June 6, 2023

Consideration of a Site Plan & Architectural Review application to construct a mixed-use development comprised of 3 buildings containing a total of 45 multi-family residential units and 2514 square feet of commercial space. The 1.62 acre site is located in the Twin Creeks Transit Oriented Development (TOD) Master Plan area within the High Mix Residential (HMR) zone. The site fronts Twin Creeks Crossing and is identified on the Jackson County Assessor's map as 37S 2W 03CA Tax Lot 1500.

CENTRAL POINT STATION PHASE 2

Attachment "A" – Site Plan

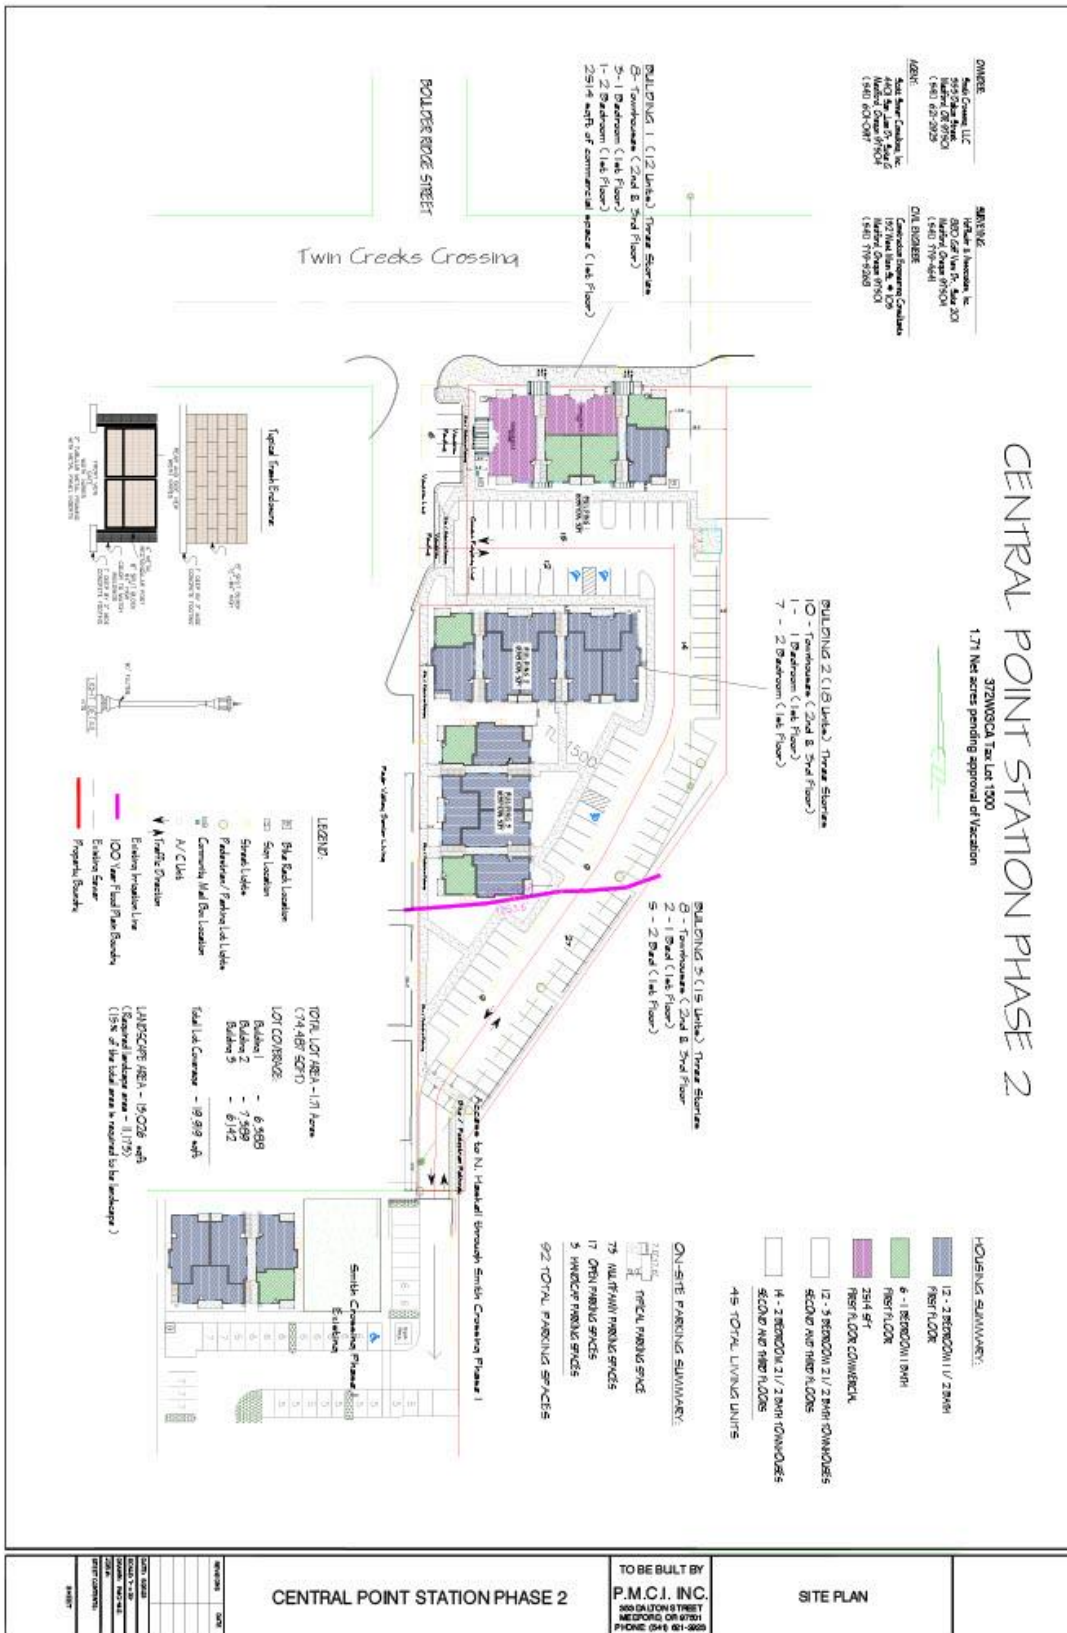
5. **Street Trees.** As shown on the Landscape Plan (Attachment “C”), street trees are proposed along the Twin Creeks Crossing frontage; however, the finished sidewalk does not include trees wells for installation.

6. **Parking Lot Landscaping and Screening.** The site plan depicts six (6) surface area parking stalls in the current Boulder Ridge Street right-of-way (to be vacated) adjacent to Twin Creeks Crossing.

Comment: In accordance with the Public Works Staff Report dated May 15, 2022 (Attachment “F”), the Applicant will be required to retrofit the sidewalk to include street trees along this section of Twin Creeks Crossing. Public Works has stated that the cost is fully eligible for SDC credits. Staff recommends Condition No. 2(c) requiring the Applicant to retrofit the sidewalks and provide the trees in accordance with the Master Plan and Public Works requirements for street tree placement.

Comment: In accordance with 17.67.050K)(2)(b), the Applicant will be required to add a five (5) foot planting strip as a landscape buffer between the Twin Creeks Crossing right-of-way and the six (6) surface area parking stalls on the project site.
